RECEIPT DATE: 7/28/17 **ONSITE SEWAGE DISPOSAL SYSTEM** P 561473
 APPROVAL DATE: 8/24/17 **PERMIT: CONSTRUCTION** A _____
 PROPERTY ADDRESS: 5054 GAITHER'S CHANCE DRIVE, CLARKSVILLE, MD 21029
 SUBDIVISION: GATHER'S CHANCE LOT: 9 TAX ID: 05-598955
 CONTRACTOR: Matfield's Equipment EMAIL: _____
 CONTRACTOR ADDRESS: P.O. Box 519 / Annapolis Junction, MD 20701 PHONE: 410-984-0047
 PROPERTY OWNER: MB GAITHERS CHANCE LLC EMAIL: MQUINT@MITCHELLBEST.COM
 OWNER ADDRESS: 1686 E GUDE DR., ROCKVILLE, MD 20850 PHONE: 443-691-4201

SITE PLAN FOR SEPTIC SYSTEM INSTALLATION

GAITHER'S CHANCE
 LOT 9 (5054 Gaithers Chance Drive)
 PLAT No. 23701

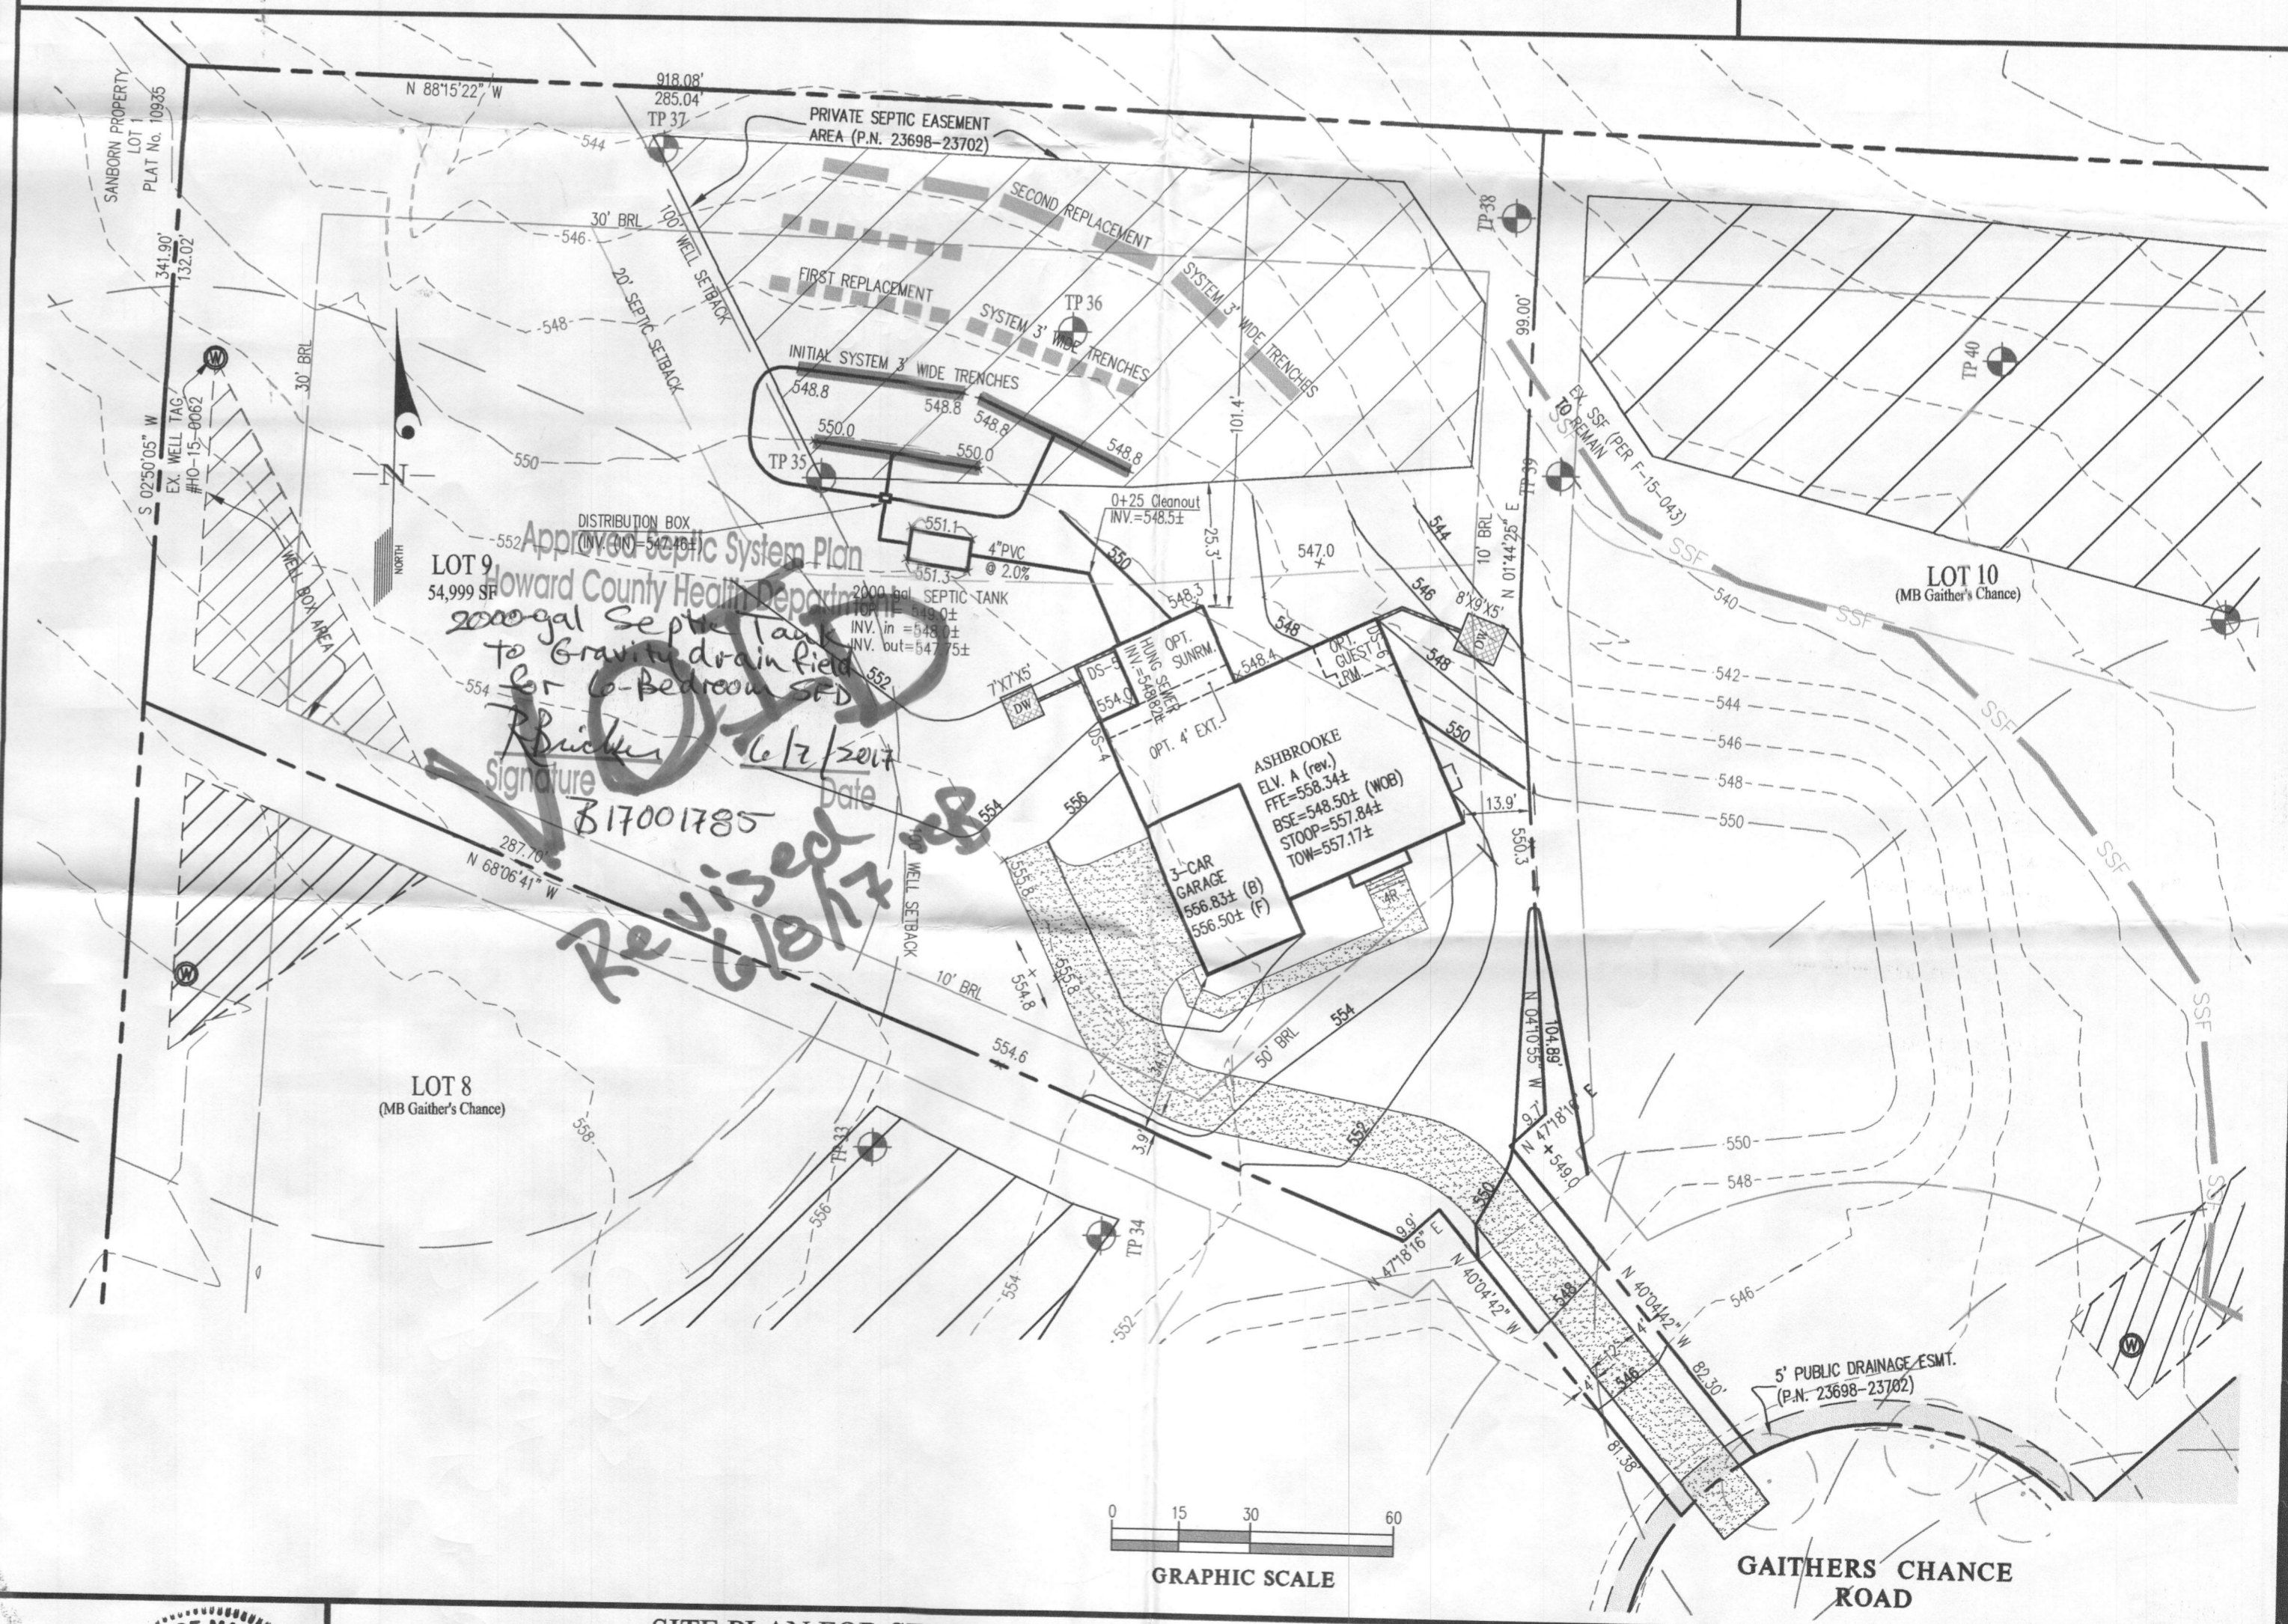
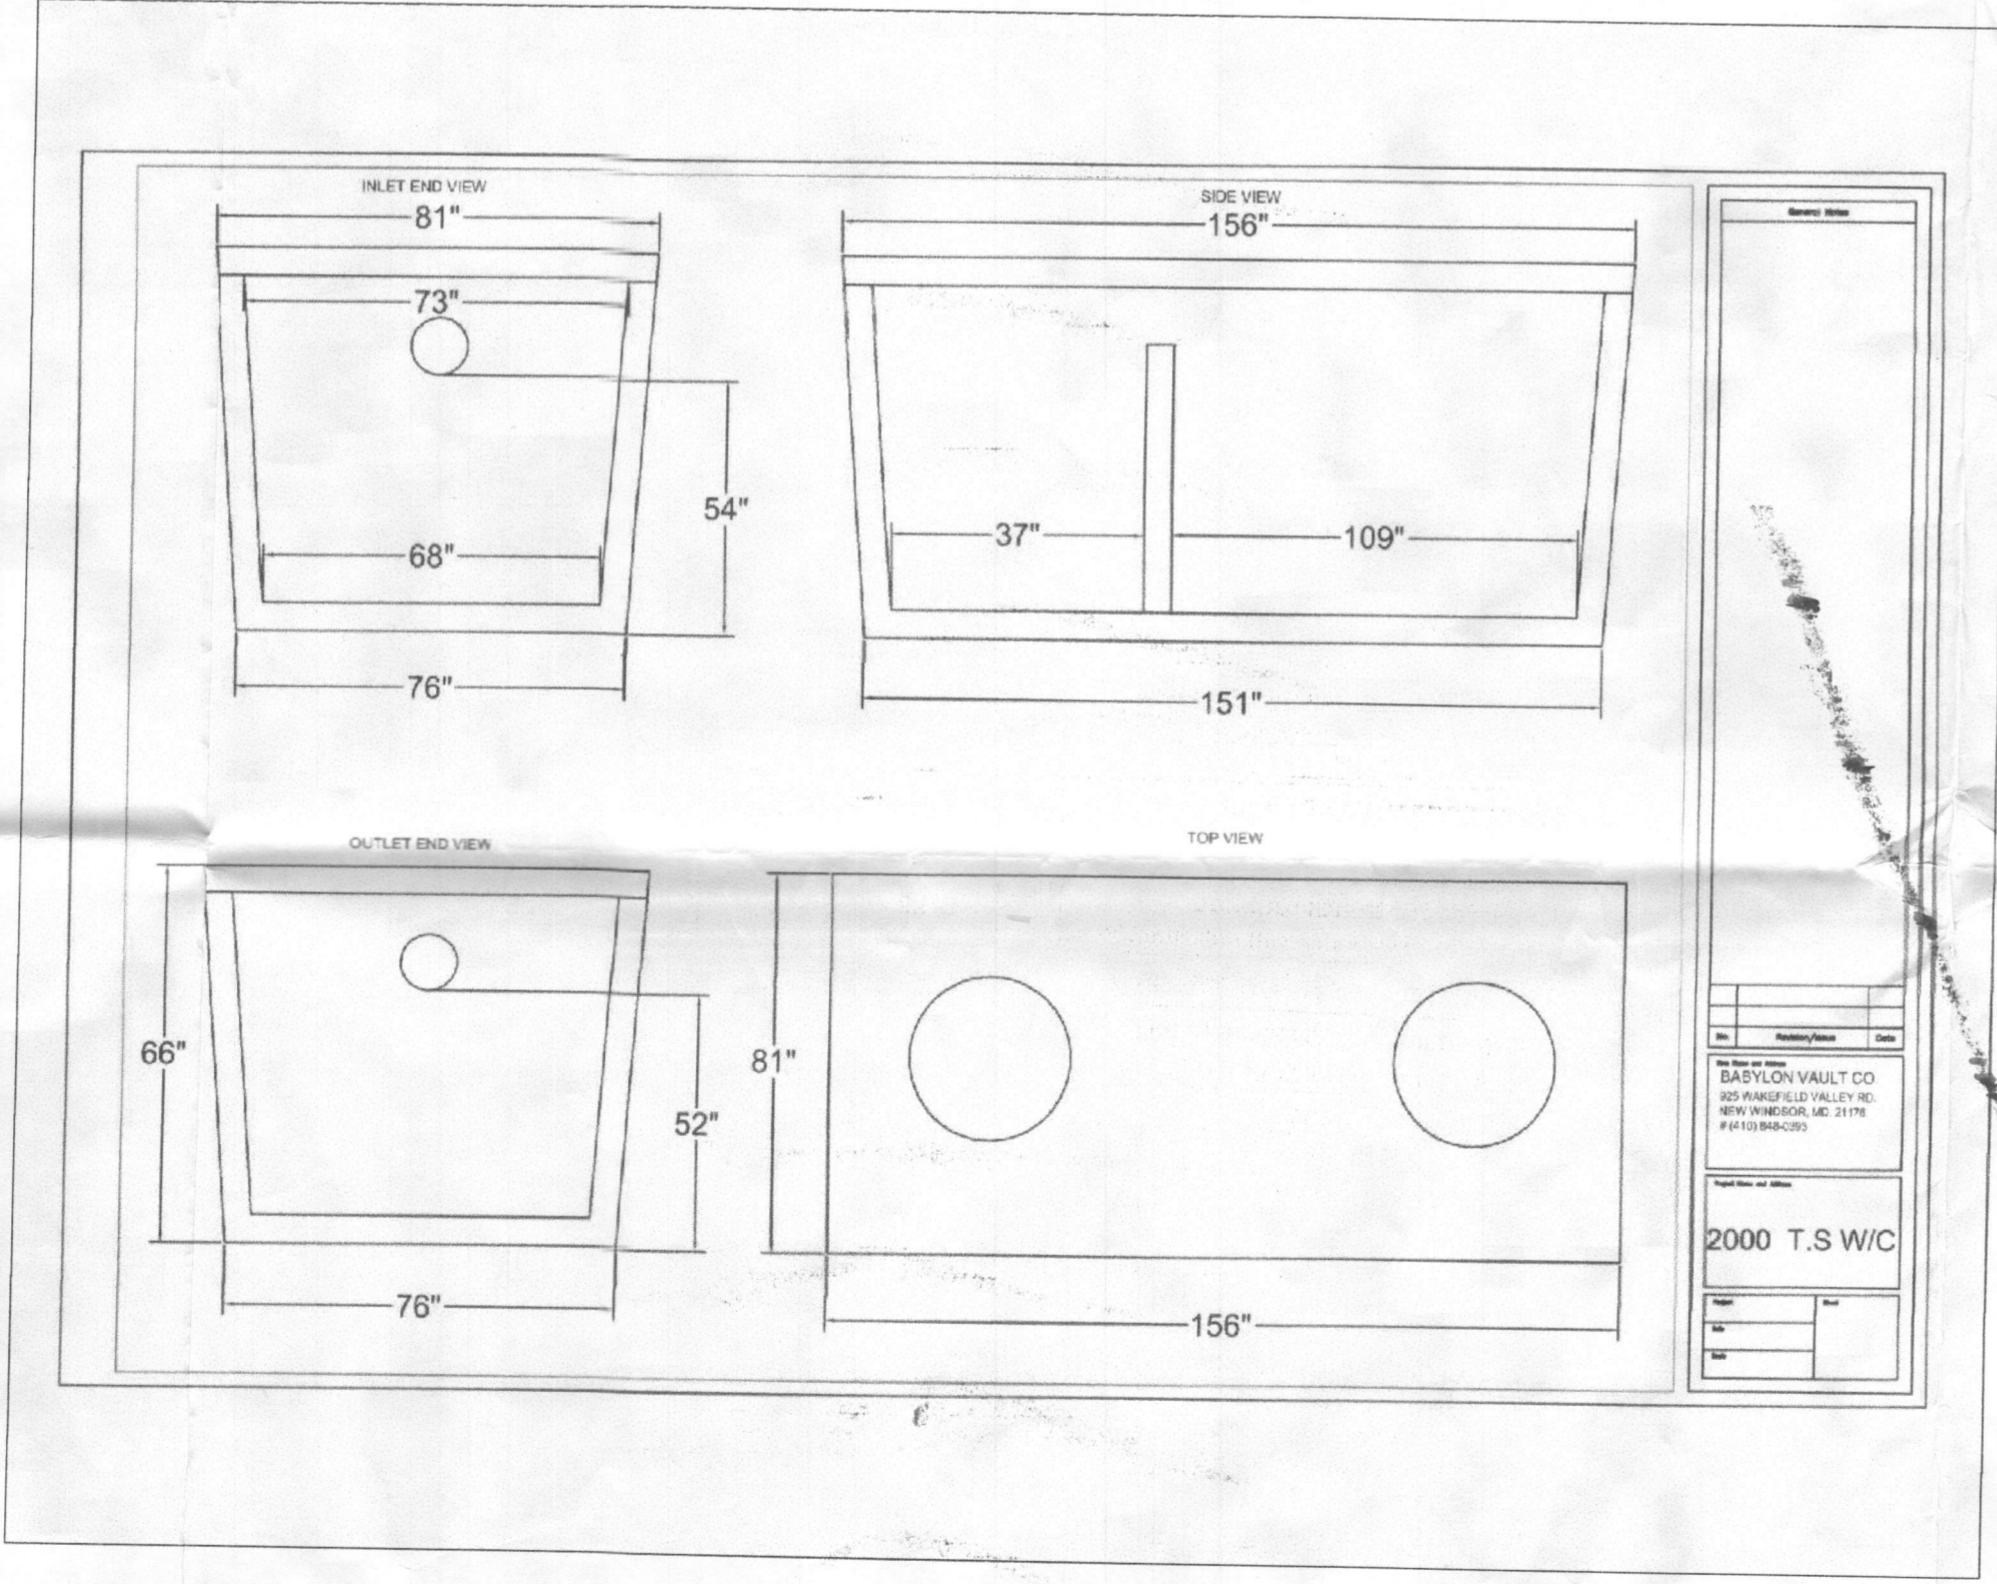
8/10/17 Met Hatfield's on site for layout. Tank, SDA corners, and 3x35' trenches staked. Shot contour + extended two trenches on W side of SDA to 53', pulled stakes from T2. Angle tank to put D-box in center of upper SDA line. Use transit while digging b/c start of T1 is 5" lower than end. (SC)

INSTALLATION: 8/23/17 Hatfield's digging T2 + adding stone and pipe. Not using laser - asked them to start using it and they did. House connection made + tank set. Pipe run from house to D-box. Trench 3' wide, 7' bottom, 2.5' to stone. (SC) 8/24/17 T1 complete + left open for inspection. 3' wide, 2.5' to stone. Levelled speed levelers in D-box. (SC)
